**CHANGE/ERRATA INFORMATION****ISSUE NO: 4      4/85**

Title: 1953A  
Print Date: January 1975  
Rev.- Date: 4-1/79

Figure 1.

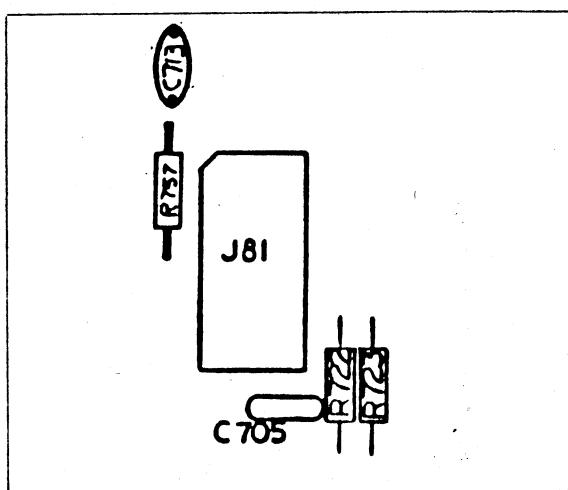
ADD: C713 | CAP, CER, 0.0012 UF  $\pm 10\%$ , 500V | 106732 | 71590 | CF122 | 1CHANGE: R754, R756 | RES. COMP, 100K  $\pm 5\%$ , 1/4W | 148189 | 01121

| CB1045 | 3TO: R754, R756 | RES. DEP. CAR. 100K  $\pm 5\%$ , 1/4W | 348920 | 80031
| CR251-4-5P100K | 3CHANGE: R757 | RES, COMP, 100K,  $\pm 5\%$ , 1/4W | 148189 | 01121
| CB1045 | REFTO: R757 | RES. CF. 10  $\Omega \pm 5\%$ , 1/4W | 340075 | 80031

CR251-4-5P10E | 1

On pages 612-11/612-12, and 8-38, Figures 612-5 and 8-15, add C713 and R757 as shown in Figure 1.

Figure 2.

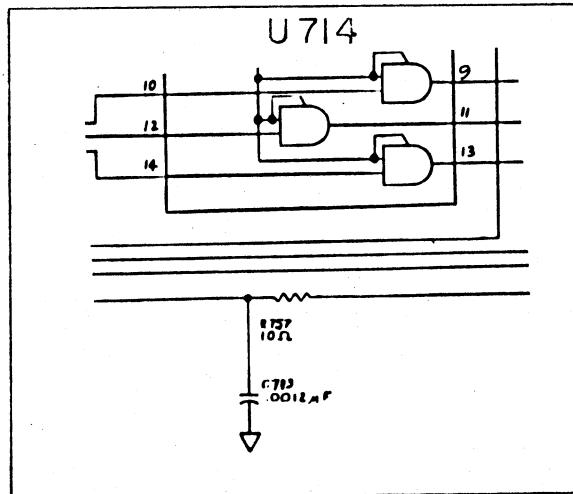
On page 8-40 (2 of 2), Figure 8-15, add C713 and R757 as shown in Figure 2.

Figure 3.

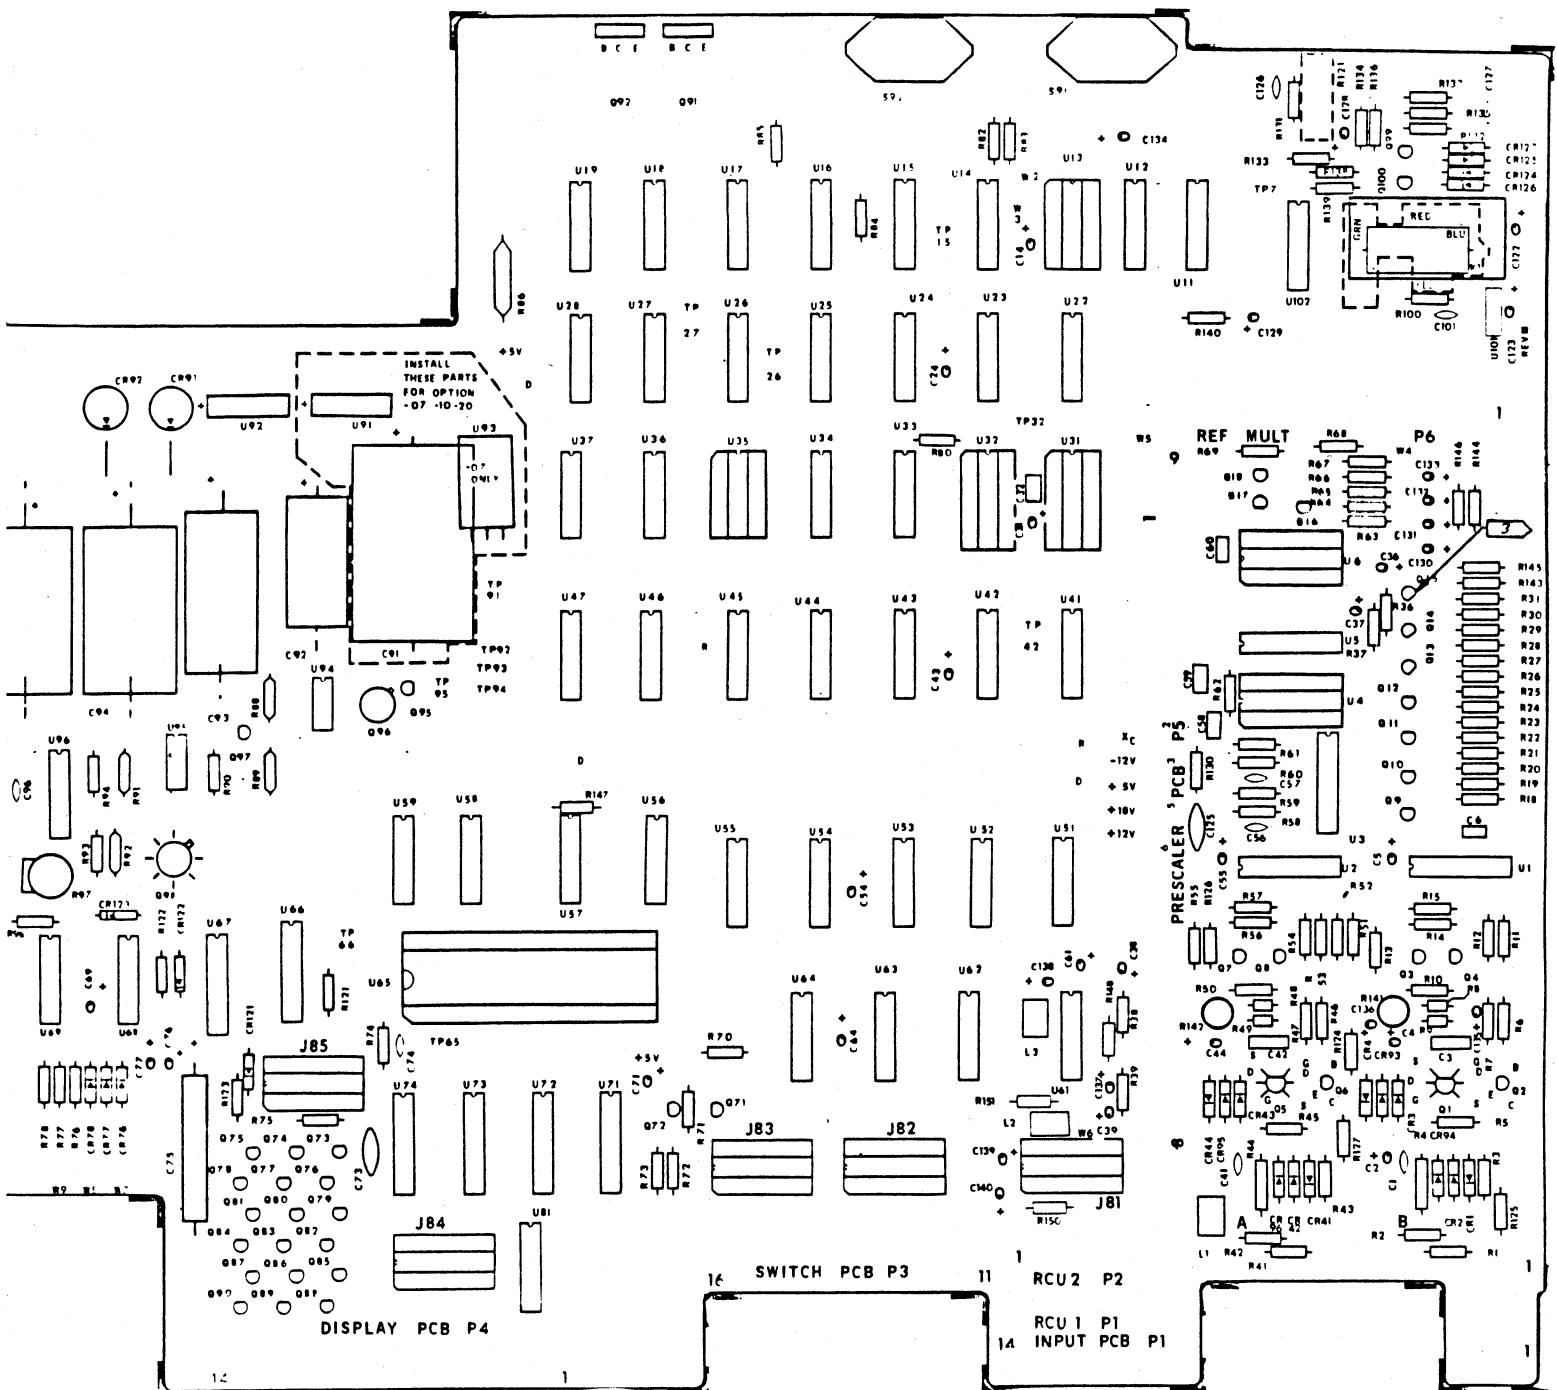
Change the TOT QTY of R29, FROM: 7 TO: 6

CHANGE: R96| RES. COMP 5.6K  $\pm 5\%$ , 1/4W| 148080| 01121

TO: R96| RES. CF 5.1K  $\pm 5\%$ , 1/4W | 573329| 80031

On pages 5-15, 8-4, and 8-13, replace Figures 5-3 and 8-2 with Figure 3.

3 ITEM 10, REF DES Q15, MUST BE INSTALLED BACKWARDS OR ROTATED 180° FROM Q9 THRU Q14, WHEN THIS TRANSISTOR IS PAINTED WITH A RED DOT.  
NOTE: TRANSISTORS WITH RED DOT MUST BE PREPARED REVERSE OF STANDARD DEVICE.

Figure 4.

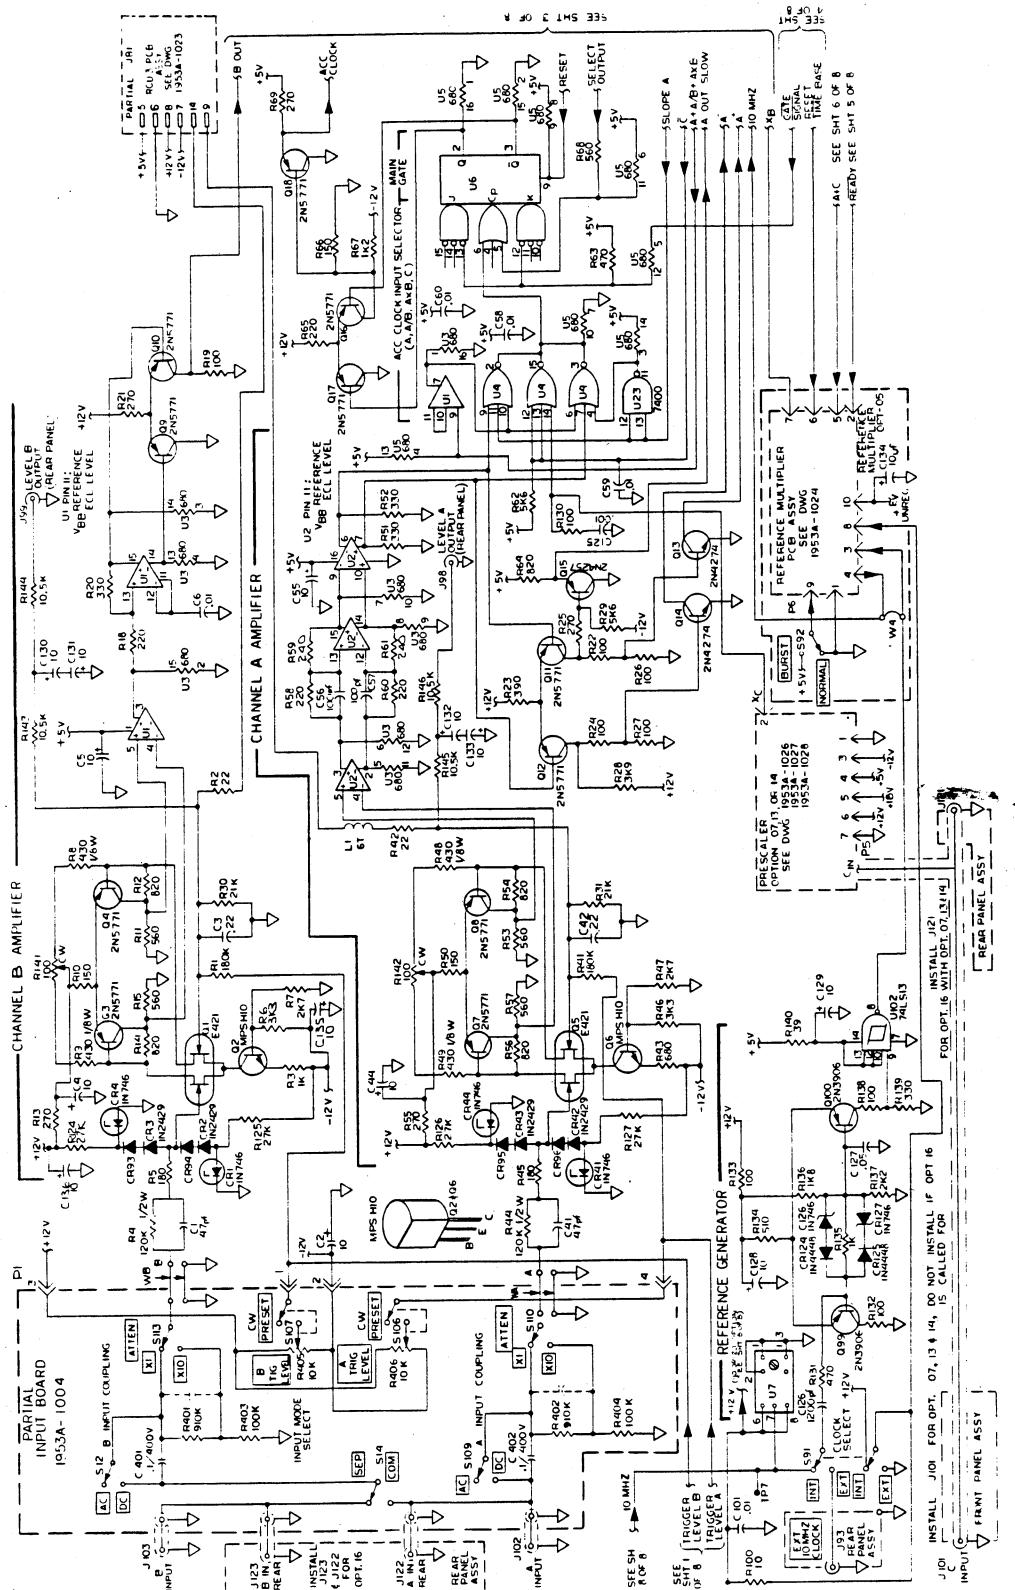
On pages 5-15, 8-4, 8-6, 8-7 and 8-13, Figures 5-3 and 8-2 (2 of 8 and 3 of 8), make the above changes as shown in Figures 3, 4, and 5 of this change/errata.

On pages 8-6 and 8-7, Figure 8-2, replace sheets (2 of 8 and 3 of 8) with Figures 4 and 5.

Figure 5.

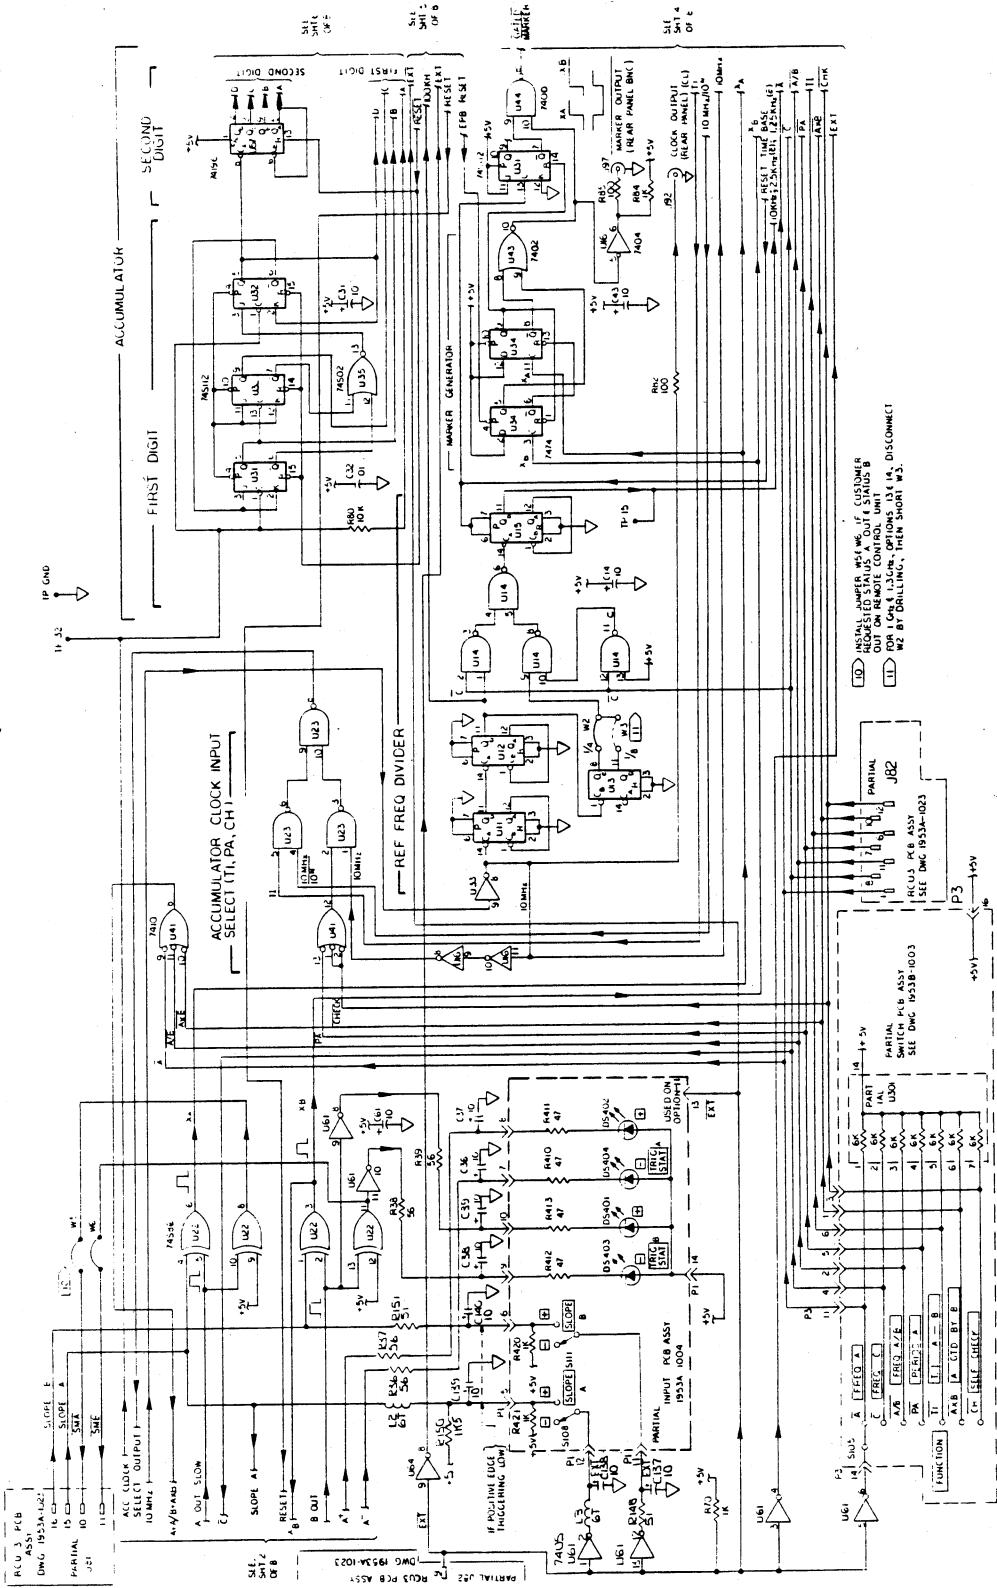
If U13 is installed for the 1 GHz and 1.3 GHz Options -13 and -14, disable W2 by drilling out the pad and hole-through plating (use a drill bit #52). Short W3 by installing a jumper between both pads of W3 and solder both sides.

Figure 6.

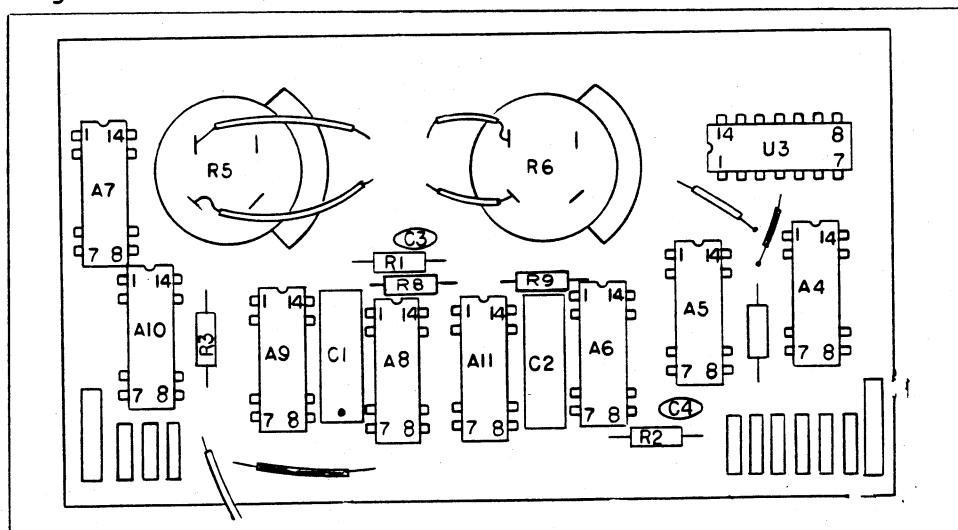
ADD: R8,R9 | RES, CF, 1K, +5%, 1/4W | 343426 | 80031 | CR251-4-5P1K | 2

On pages 612-8 and 8-36, Figures 612-4 and 8-14, add R8 and R9 as shown in Figure 6.

Figure 7.

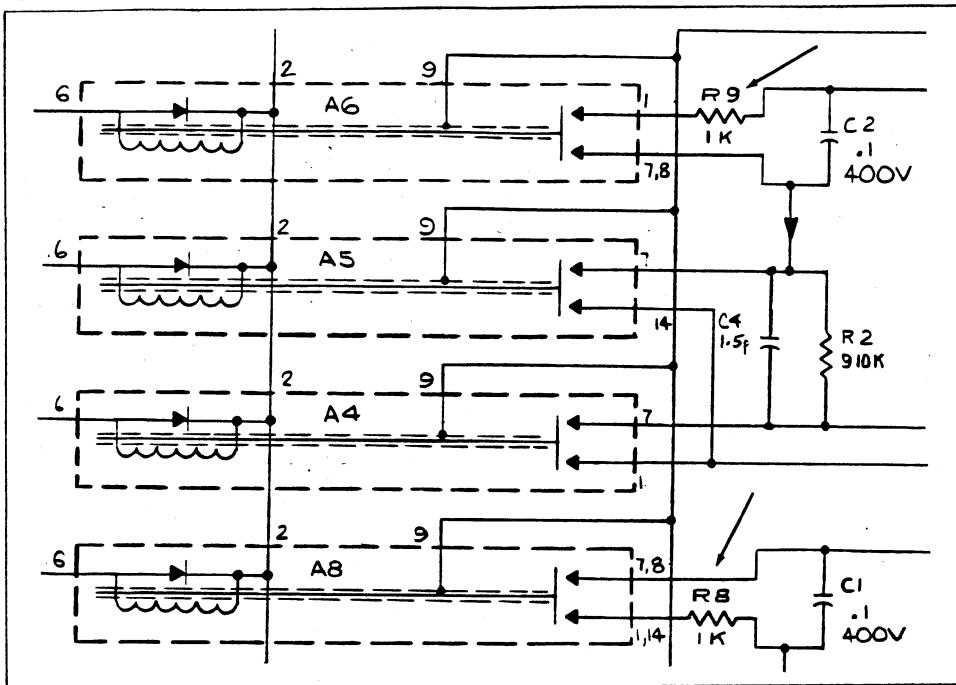
On page 8-37, Figure 8-14, add R8 and R9 as shown in Figure 7.

Figure 8.

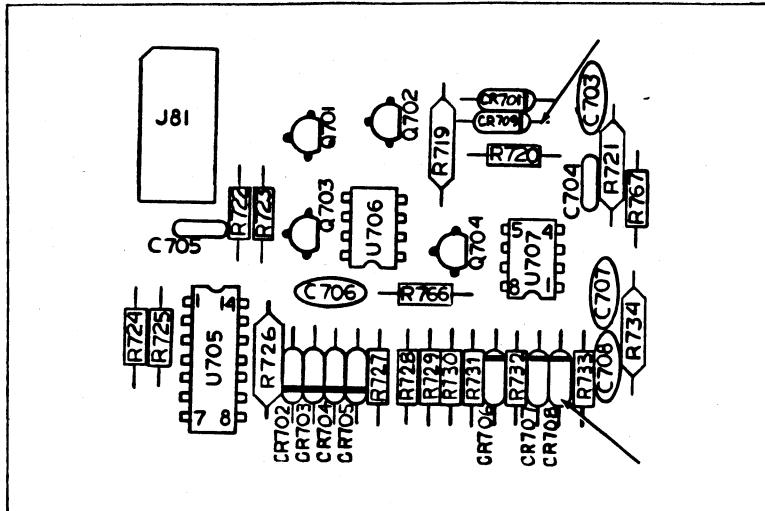
ADD: CR708,CR709 | DIODE, ZENER, UNCOMP, 6.2V, 5%, 20.0MA, 1/4W | 325811

On pages 612-11/612-12, and 8-38, Figures 612-5 and 8-15, add CR708 and CR 709 as shown in Figure 8.

Figure 9.

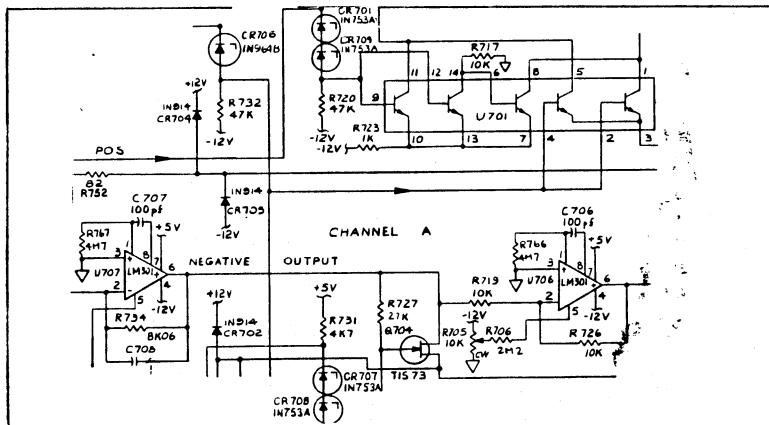
CHANGE: CR701 | DIODE, ZENER, 12V, 400MW | 110726

TO: CR701 | DIODE, ZENER, UNCOMP, 6.2V, 5%, 20.0MA, 1/4W | 325811

CHANGE: CR707 | DIODE, ZENER, 12V, 400MW | 110726

TO: CR707 | DIODE, ZENER, UNCOMP, 6.2V, 5%, 20.0MA, 1/4W | 325811

On page 8-39, Figure 8-15, make the changes listed on the previous page as shown in Figure 9.

Figure 10.

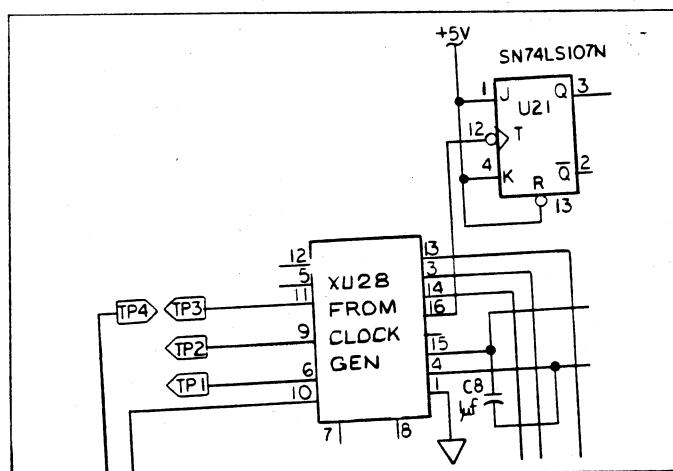
Change #13 documents the steps to be taken when replacing U28, P/N 404459, on the 1953A-4041 PCB assembly. When ordering a replacement for U28, order kit 1953A-7015K, P/N 762070. Installation instructions are included in the kit. Complete the following changes in your manual when you have received the replacement kit.

**CHANGE:** U28 | IC, CLOCK GENERATOR, MICRO-COMPUTER SET | 404459 | 34649

**TO:** U28 | IC, CLOCK GENERATOR PCB ASSY TESTED | 752279 | 89356

On page 8-33, Figure 8-12, make the changes previously listed as shown in Figure 10.

Figure 615-10.

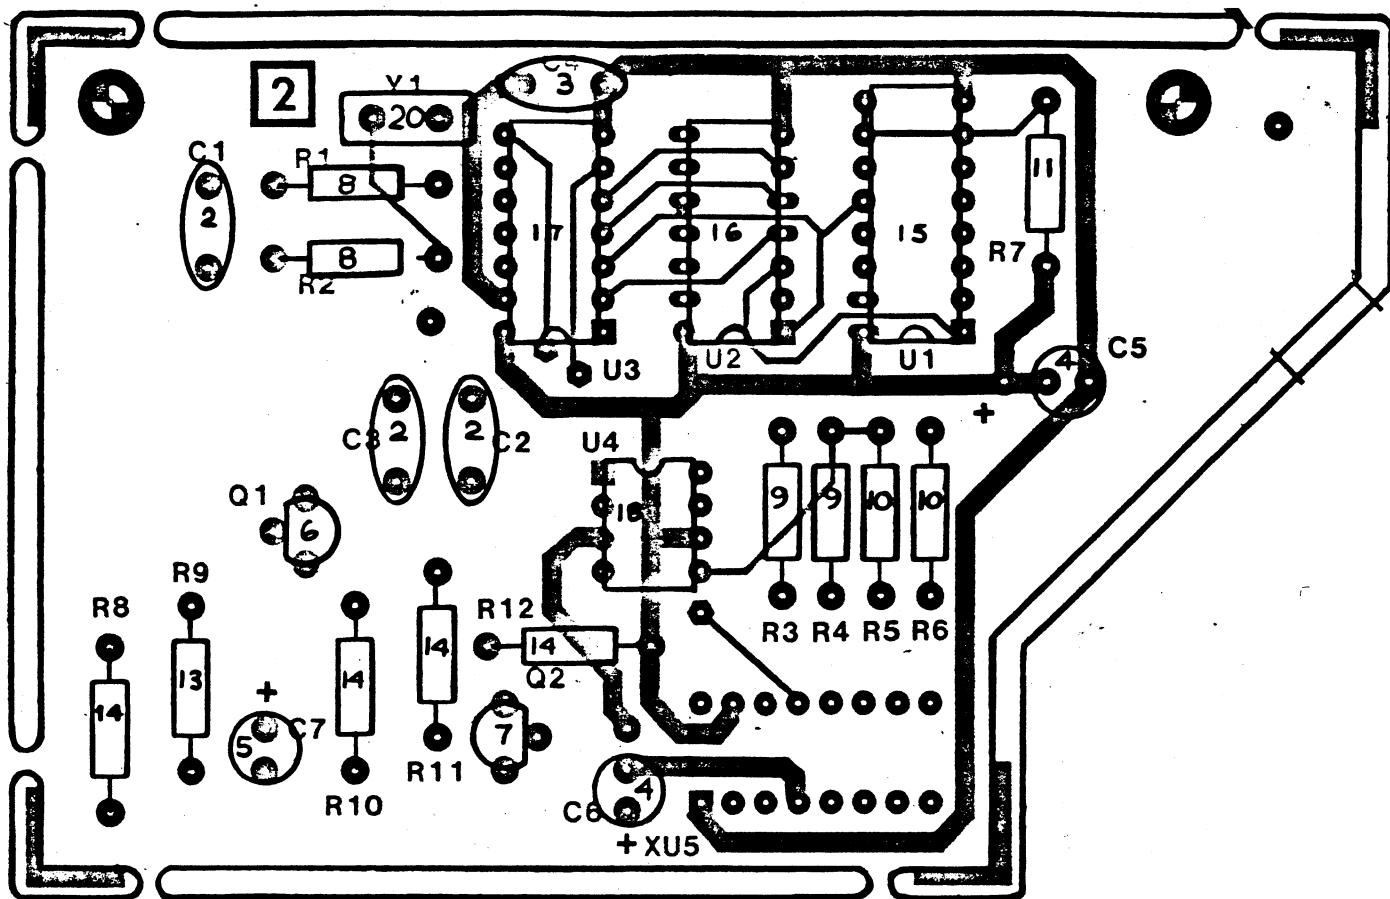
On page 615-16, add Table 615-13a., Figures 615-10 and 615-11.
